## Reviewers' comments (Oct. 11th, 2017)

Reviewer #1: Dear Author, please find here a list of comments from my side.

Figure 1: The number of active pads versus the measured momentum of the elastic  $^4\text{He}$  tracks.

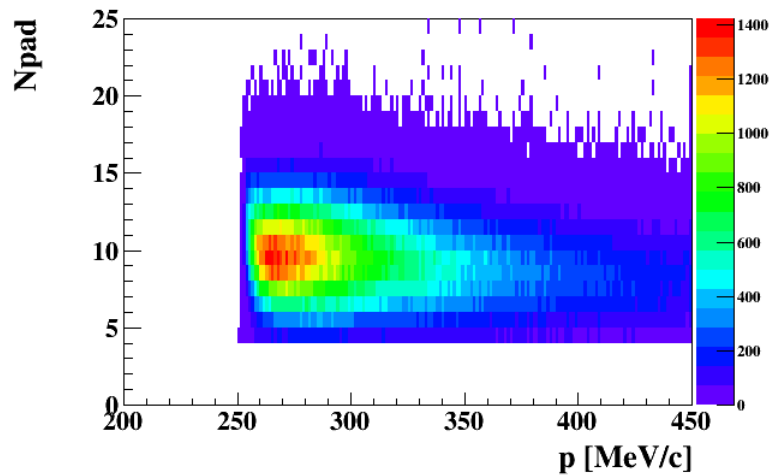
16. Figure 11: I don't understand it. How many tracks does the histo contain? If the single pad has 128 channels, how many channels does the single bin contain? Moreover, is the dE calculated on pad by pad basis? In that case, why don't you put just one point in the histo for each pad? What is the mean number of channels or pads fired by one track? Sorry for the list of questions, but I could not understand the figure.

- It is for only one track (written in the caption). - We don't understand your second question. A pad is a channel. Do you mean how many pads are fired for a single track? Figure ?? shows the number of active pads as a function of the momentum for the collected elastic  $^4\text{He}$  tracks.

- dE is calculated from the ADCs of the individual pads that read out hits corresponding to the same track. One needed to know the individual step size very precisely to put dEdx from the individual pads, which is not available. - Last question is addressed by figure ??.

The mean value is around 10 pads.

Figure 2: the number of hits distribution for the collected elastic  $^4\text{He}$  tracks from the 1.2 GeV dataset.

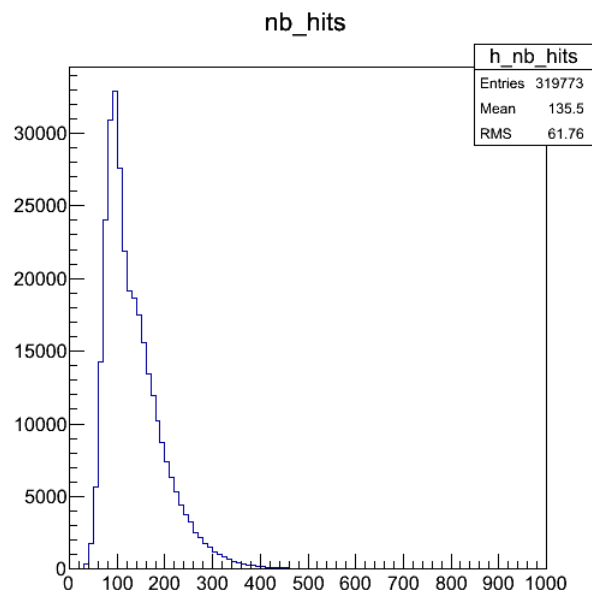
20. How was the "10 hits" cut chosen? What is the mean number of primary ionization in this gas mixture?

Figure 2 shows the number of hits distribution for the collected elastic  $^4\text{He}$  tracks from the 1.2 GeV dataset. The mean number of hits is around 135 and the 10 hits cut at the reconstruction level is a loose cut to reduce the level of the spurious tracks.
